ASH DISPOSAL SPILLWAY

KINGSTON STEAM PLANT
TENNESSEE VALLEY AUTHORITY
DIVISION OF ENGINEERING DESIGN

KNOXVILLE 5-20-76 36 C 10N422 R1

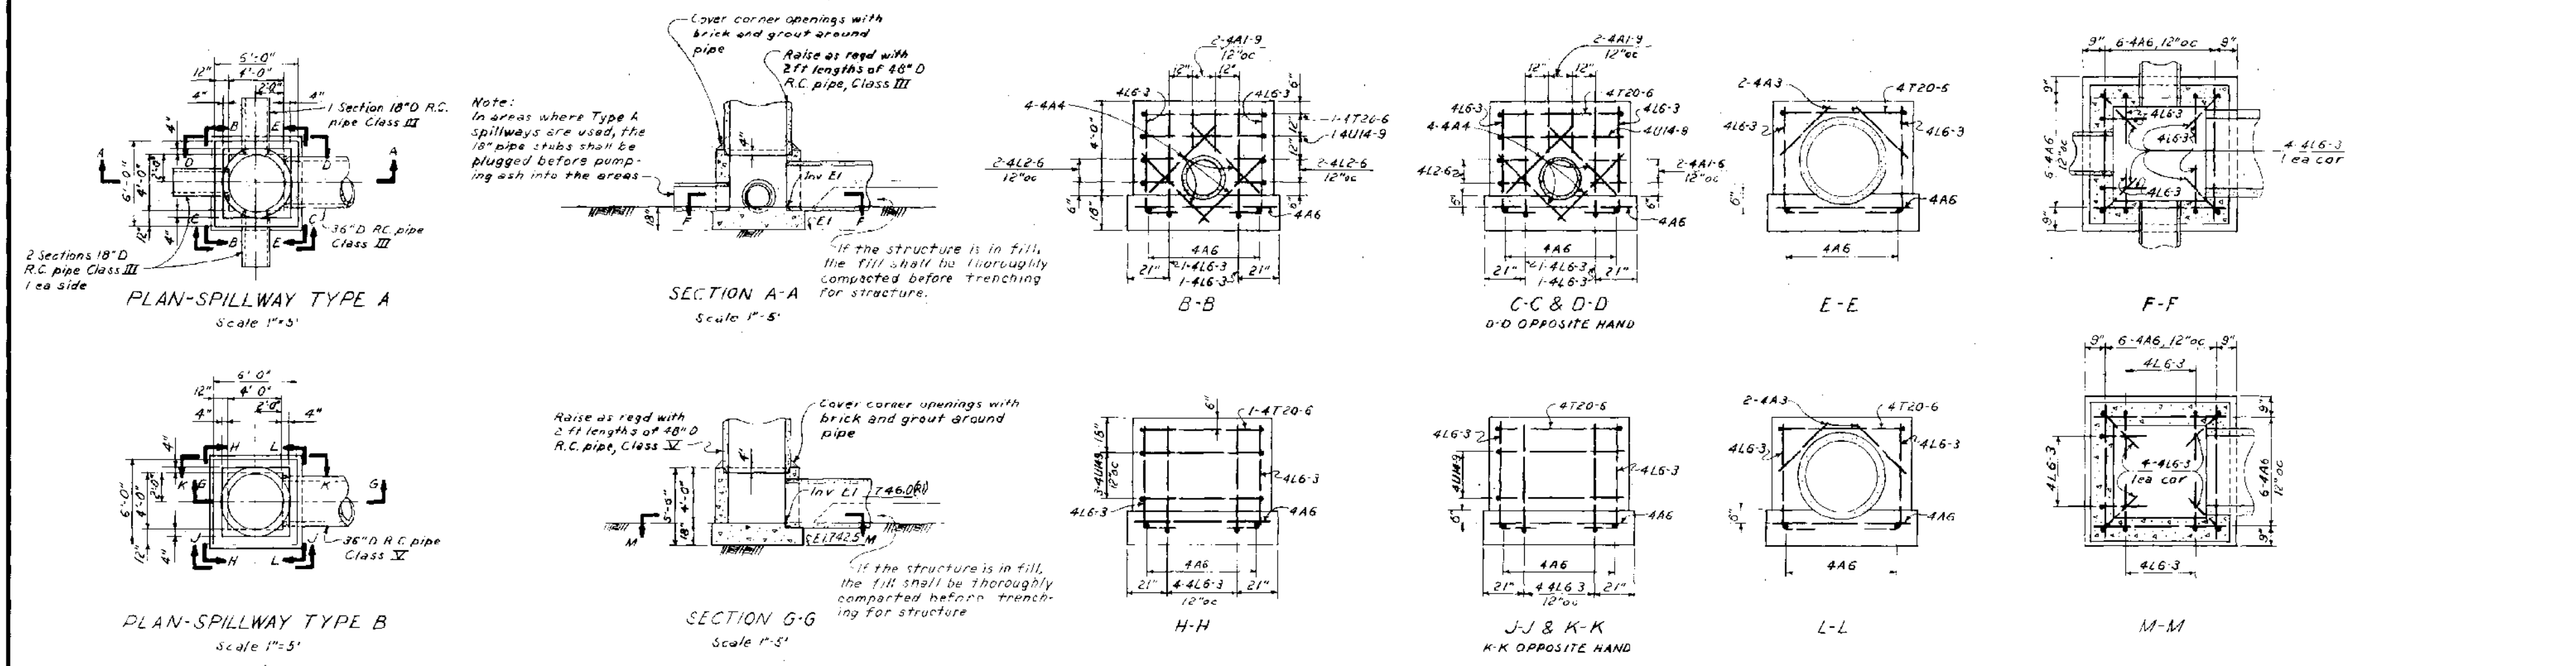
⑫ PLANT PERSONNEL SHALL DETERMINE THE NEED FOR ADDITIONAL DETENTION TIME IN THE DISPOSAL AREA AND SHALL PROVIDE THE ADDITIONAL DETENTION TIME BY ADDING A TWO FOOT SECTION OF 48" CONCRETE PIPE TO THE SPILLWAYS.

ITEM	DESCRIPTION	NO. of Splwys	PER SPLWY	TOTAL REQD
401	Class A Concrete	6	5 cu yd	30 CU YD
418	Reinforcing Steel	6	170 lb	1020 LB
~~602~~	~~18"D Reinforced Concrete Pipe-Class V Type A Only~~			
604	36"D Reinforced Concrete Pipe-Class V "O" RING	6	VARIES	936 FT
* 604	48"D Reinforced Concrete Pipe-Class V (Bell & Spigot)	6	12	72 FT
660	120"-12 Gage Corrugated Metal Pipe	6	5 ft	30 FT
	$\frac{1}{2}$" ϕ Galvanized Bolt	6	12	72
	~~$\frac{1}{8}$" Metal cover — — (By Field see Skimmer Details)~~	~~6~~	~~1~~	~~6~~
	$2\frac{1}{2} \times 2\frac{1}{2} \times \frac{3}{8}$ Angle	6	23 ft	138 FT
	$3 \times 3 \times \frac{3}{8}$ Angle	6	67 ft	402 FT
	$4 \times 4 \times \frac{3}{8}$ Angle	6	8 ft	48 FT

① SPECIFICATIONS: All work shall be done in accordance with the T-1 Specifications.
② All concrete shall be Class A in accordance with Section 400.
~~③ Where earth borrow can be obtained economically, example, from disposal area, it may be used to raise dikes.~~
~~④ Vegetation shall be established on all earth slopes, initial and future construction. Seeding specifications to be furnished with drawings for each project. In general, type 7 Section 180 of T-1 Specifications is recommended.~~
~~⑤ Location and elevation of the spillways shall be selected so as to maintain the depth of water in the ash pond at an absolute minimum.~~
~~⑥ Use Type A spillways for ash areas not scheduled for immediate use.~~
~~⑦ A section of 120" corrugated metal pipe, fully coated, shall be used for the skimmer device. All seams and joints shall be riveted. Fabrication of the pipe shall be complete prior to coating.~~

R1 REVISED & RETAINING 36" PIPE ...
